# CITY OF ALBUQUERQUE

**RE: 1938 Meadowview Ct. NW  
Grading and Drainage Plan  
Engineer's Stamp Date: 2/19/25  
Hydrology File: H13D125  
Case # HYDR-2025-00045**

Based upon the information provided in your submittal received 02/19/2025, the Grading & Drainage Plan is approved for Building Permit and Grading Permit. Please attach a copy of this approved plan in the construction sets for Building Permit processing along with a copy of this letter.

ENGINEER'S SEAL	TRACT A-1 LANDS OF AL JARRETT 1938 MEADOW VIEW CT NW	DRAWN BY DEM
DAVID SOULE REGISTERED PROFESSIONAL ENGINEER 14522	GRADING AND DRAINAGE PLAN	DATE 2-18-25
2/19/25	 Rio Grande Engineering P.O. BOX 53924 ALBUQUERQUE, NM 87199 (505) 321-9099	SHEET # C1
DAVID SOULE P.E. #14522		JOB #

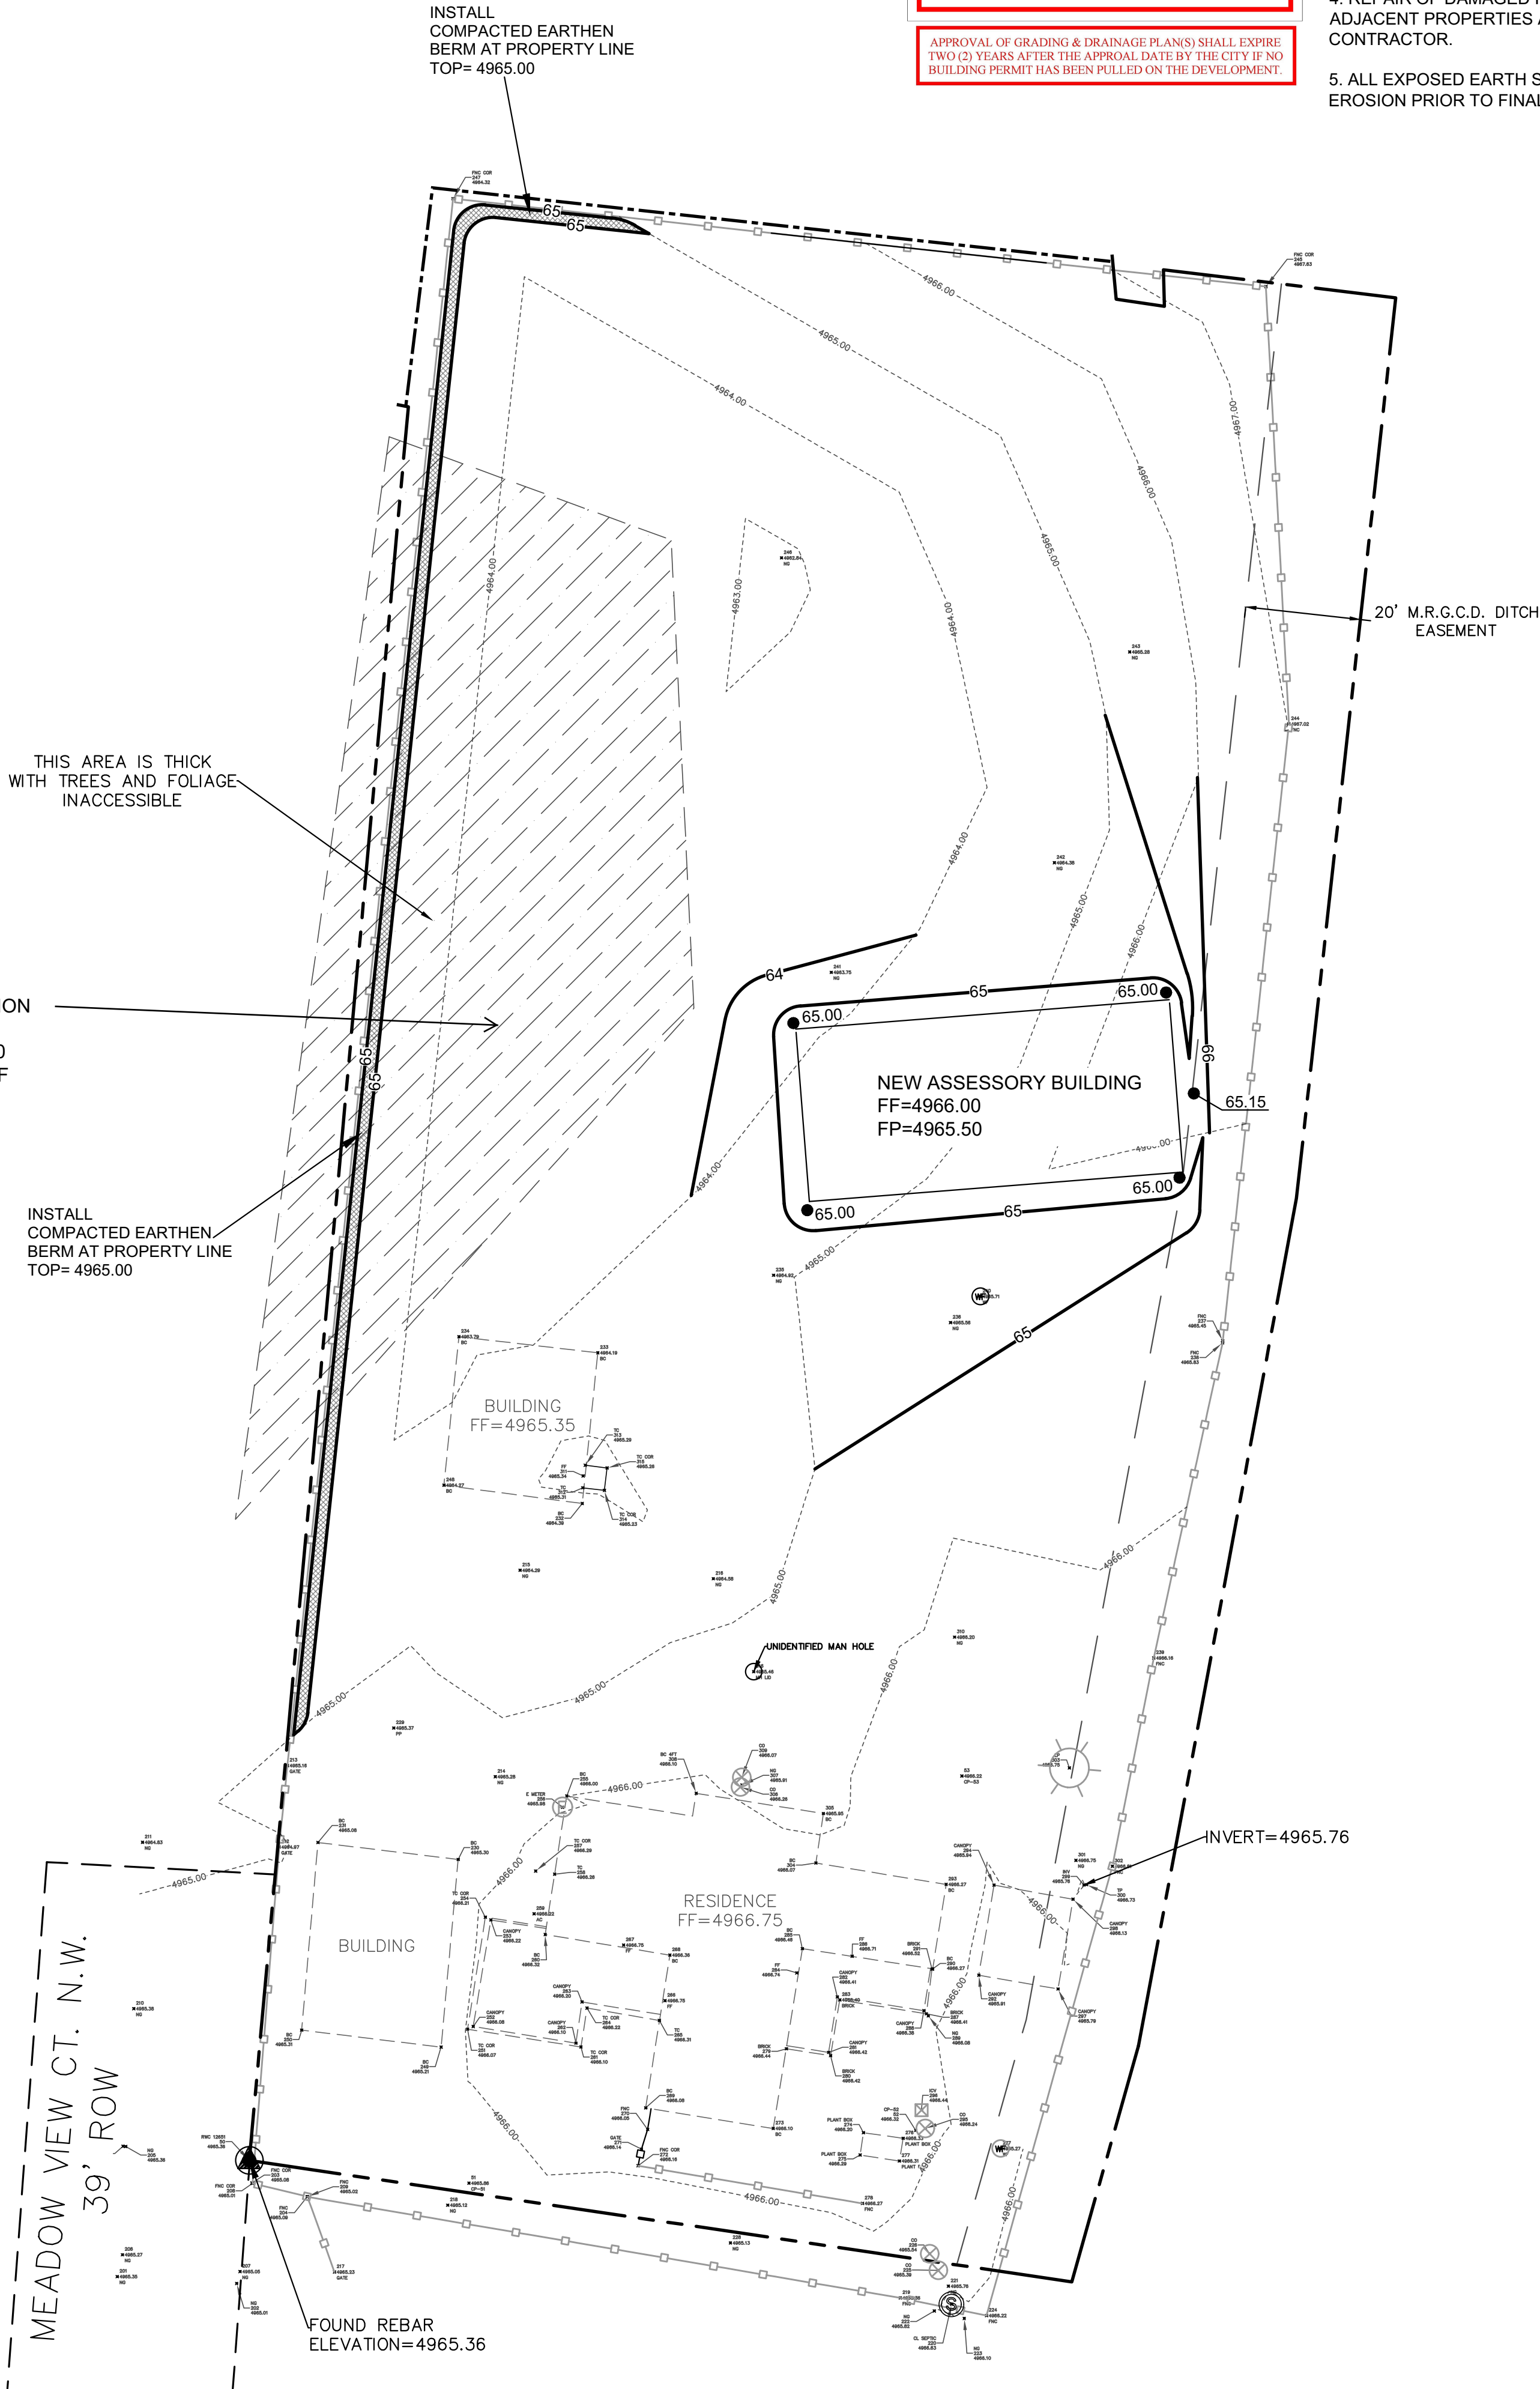
1. Engineer's Certification, per the DPM Part 6-14 (F): *Engineer's Certification Checklist For Non-Subdivision* is required.
